February 19, 2015

ADDENDUM A

Saint James Catholic Church
Phase 1 Renovations and Additions
Kearney, Nebraska
RDG Project No. 2013.203.01, File 35.1

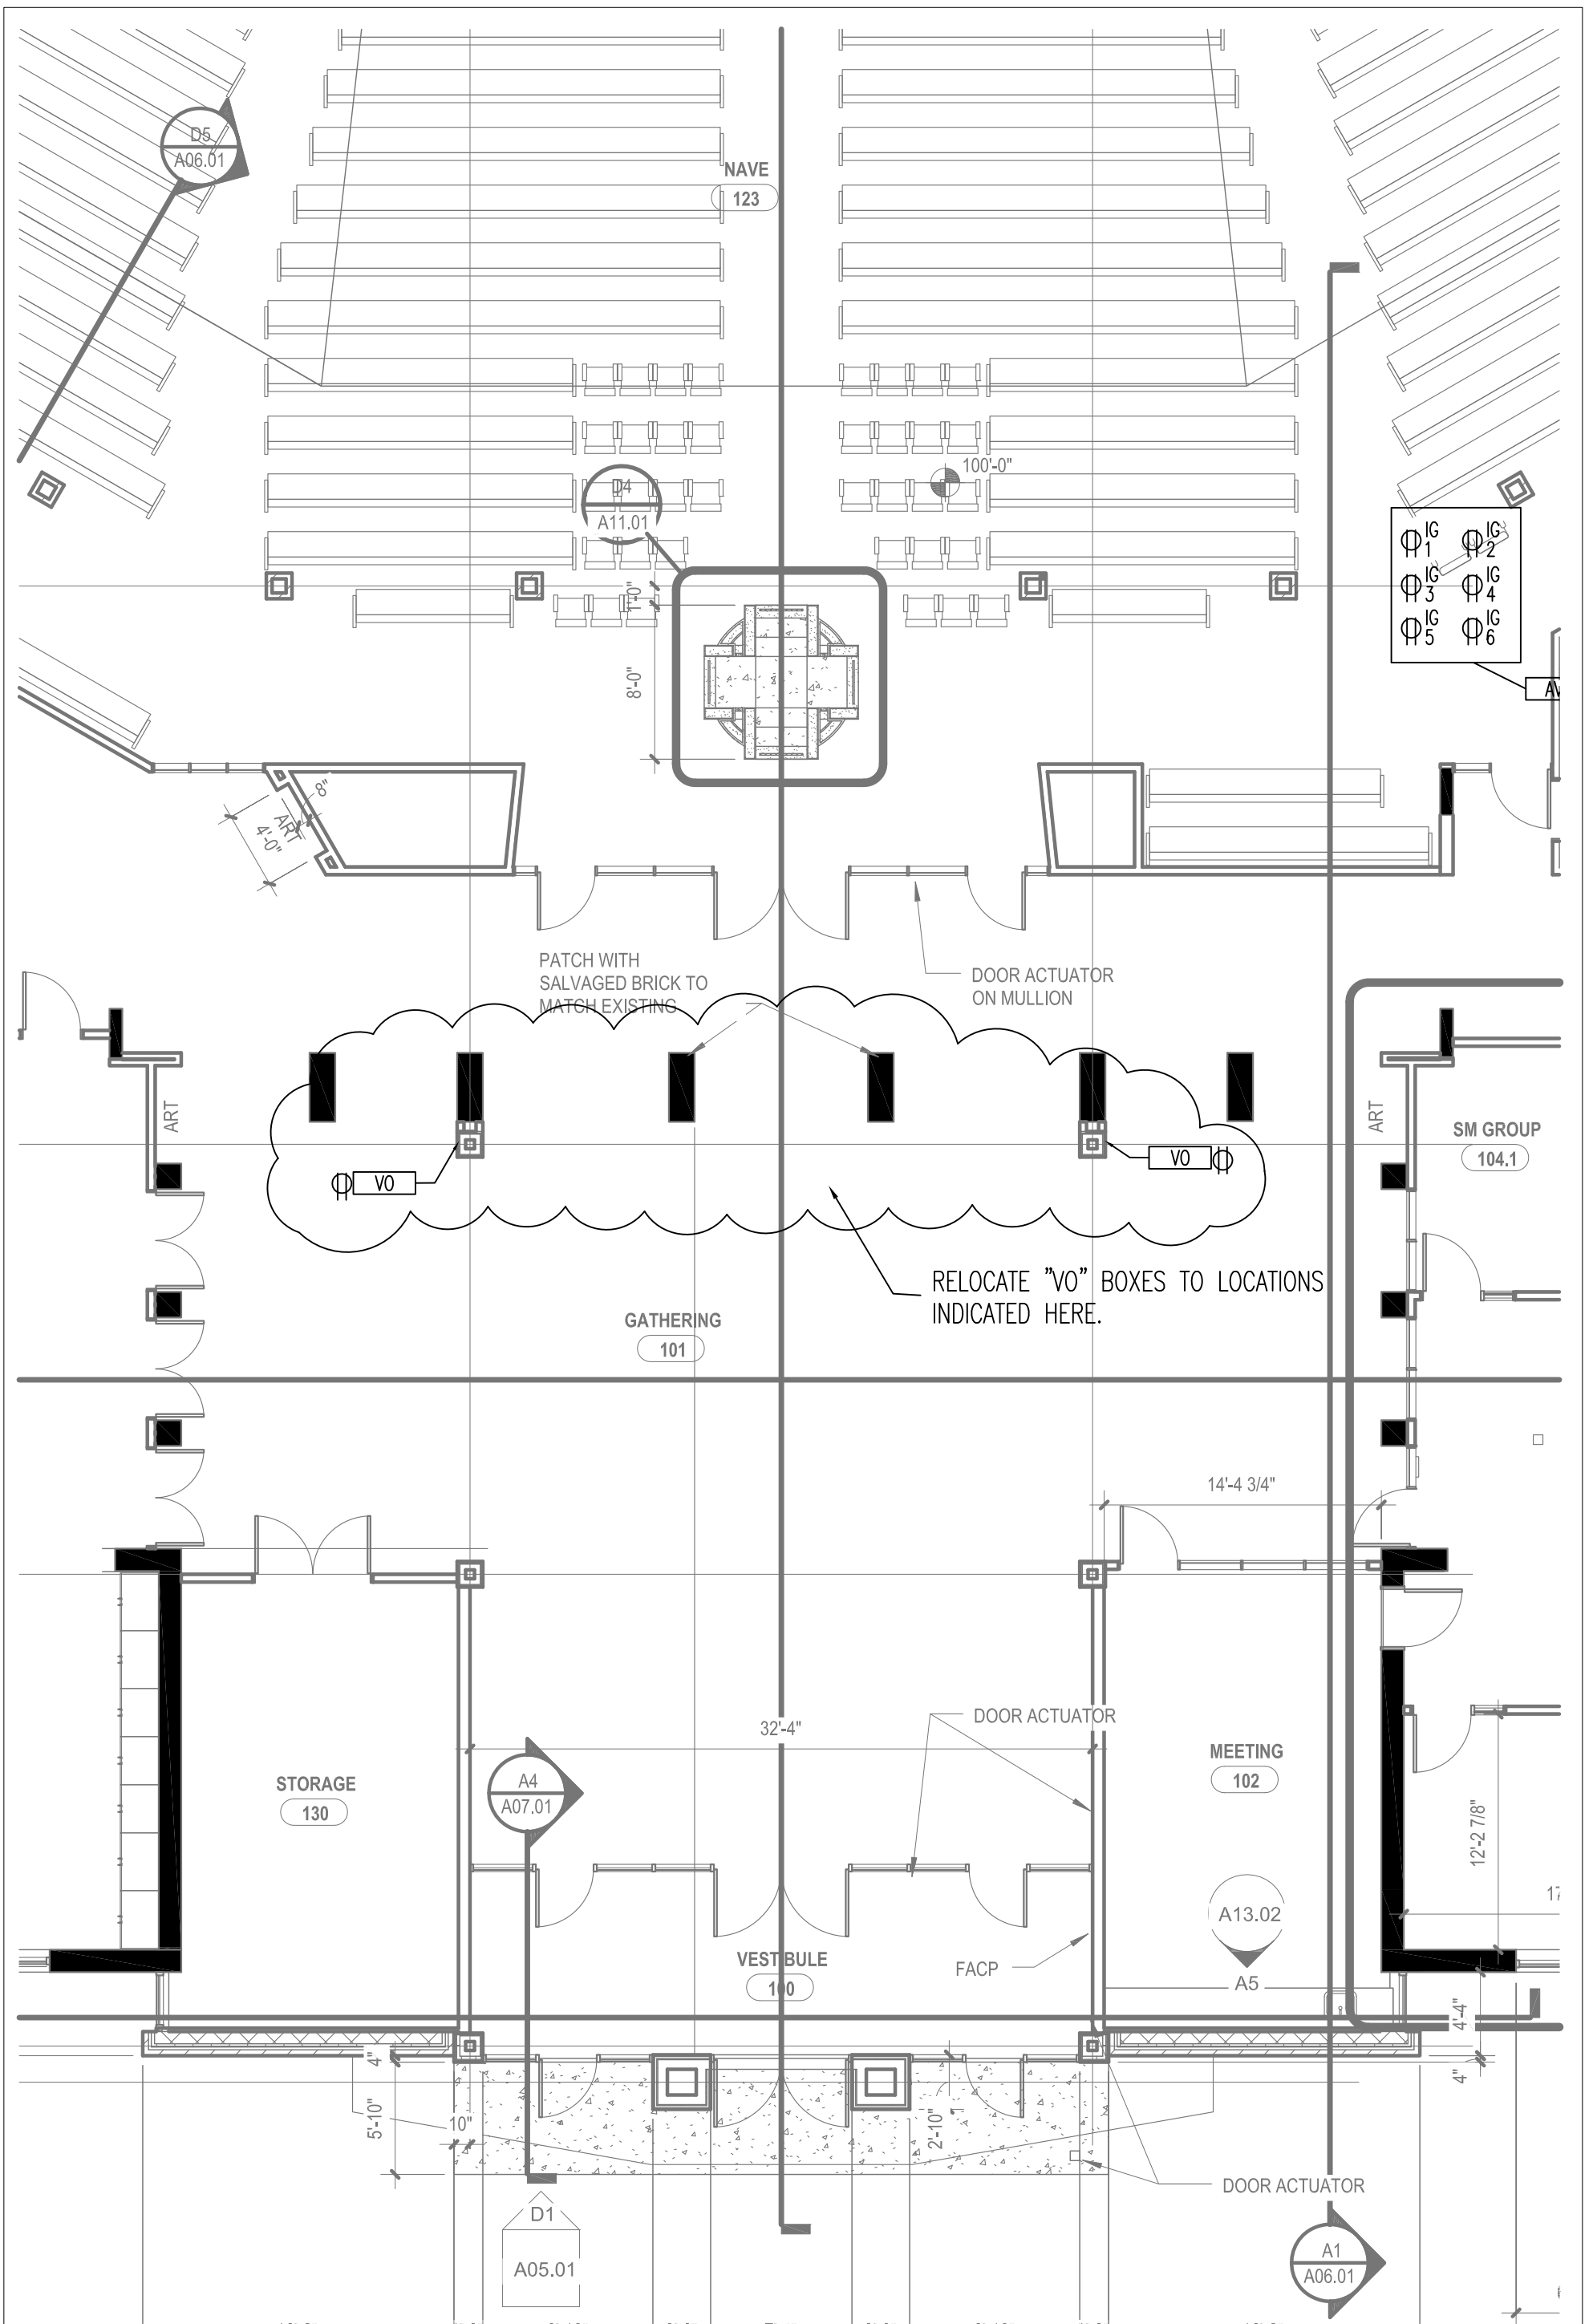
- AAVD-1 The Electrical and AV Contractors shall delete the altar microphone input, Floor Box FB2, and all associated conduits, cabling and input. See Supplemental Drawing SDAV.01.

DELETE FLOOR BOX AND ASSOCIATED CONDUIT, CONNECTIONS AND INPUT TO DSP.

E06.02

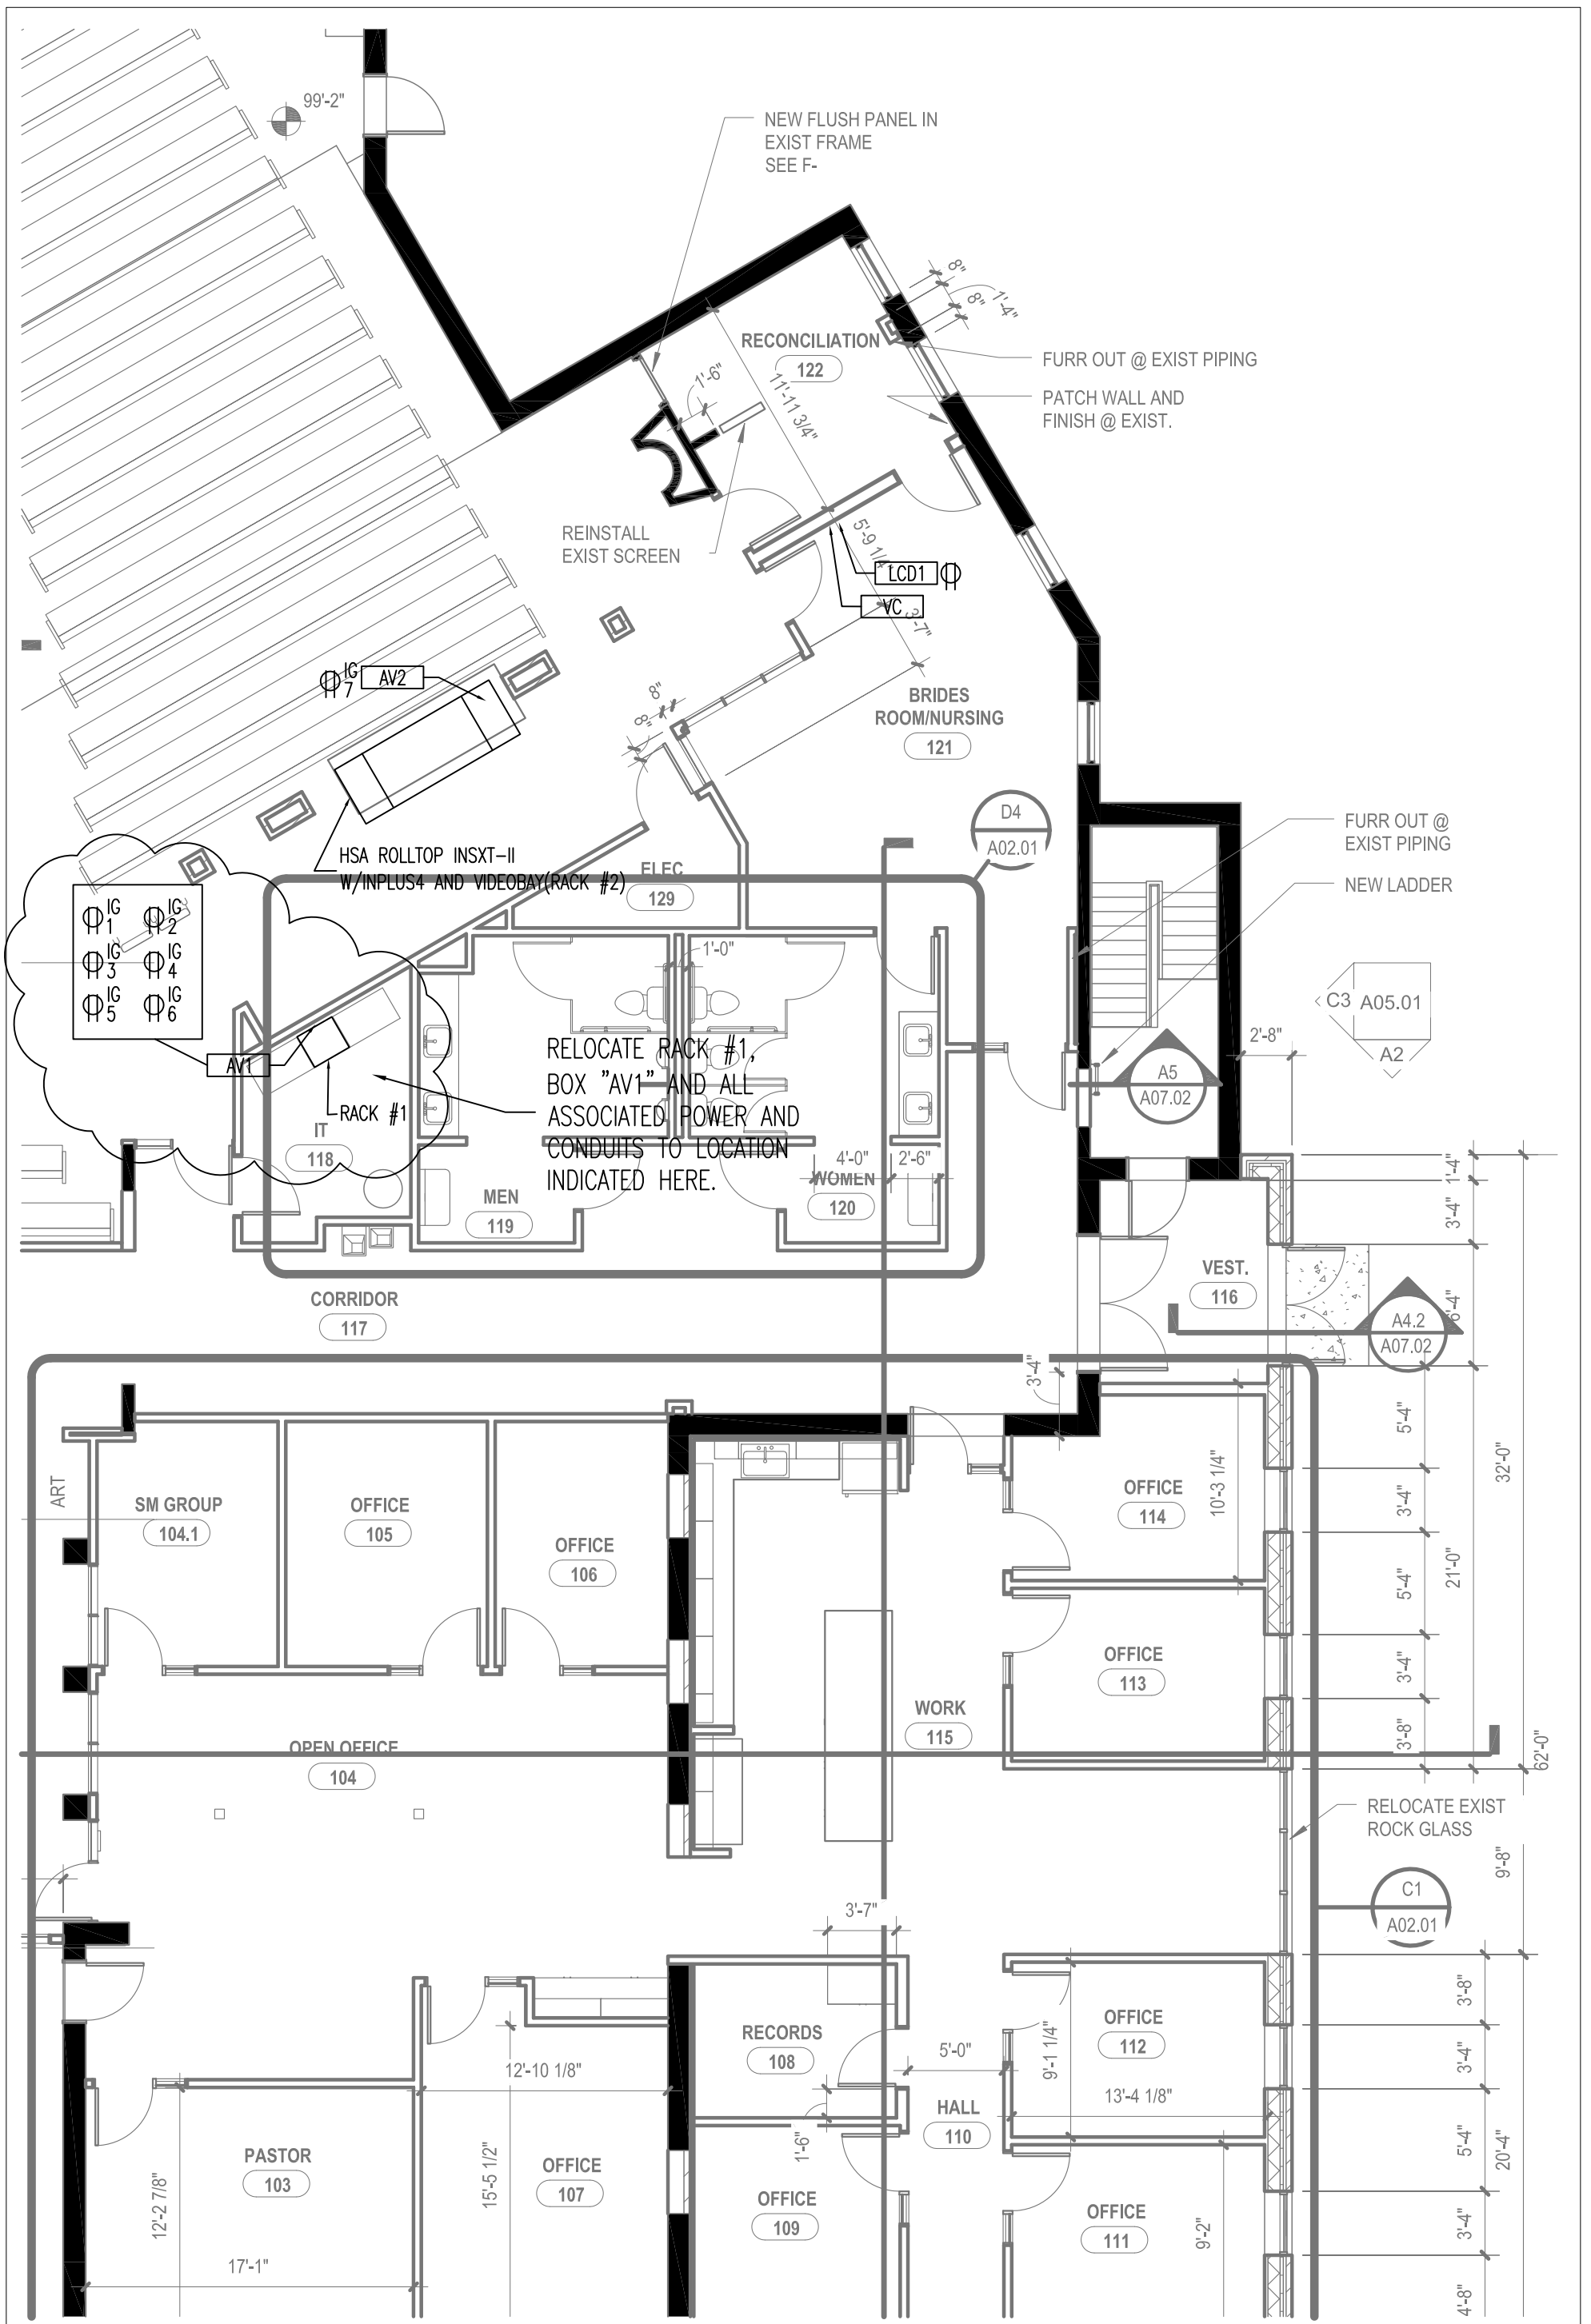
- A. Add alternate manufacturers per revised Luminaire Schedule. See revised Sheet E06.02.
- B. Add Luminaire Type 23 per revised Luminaire Schedule. See revised Sheet E06.02.
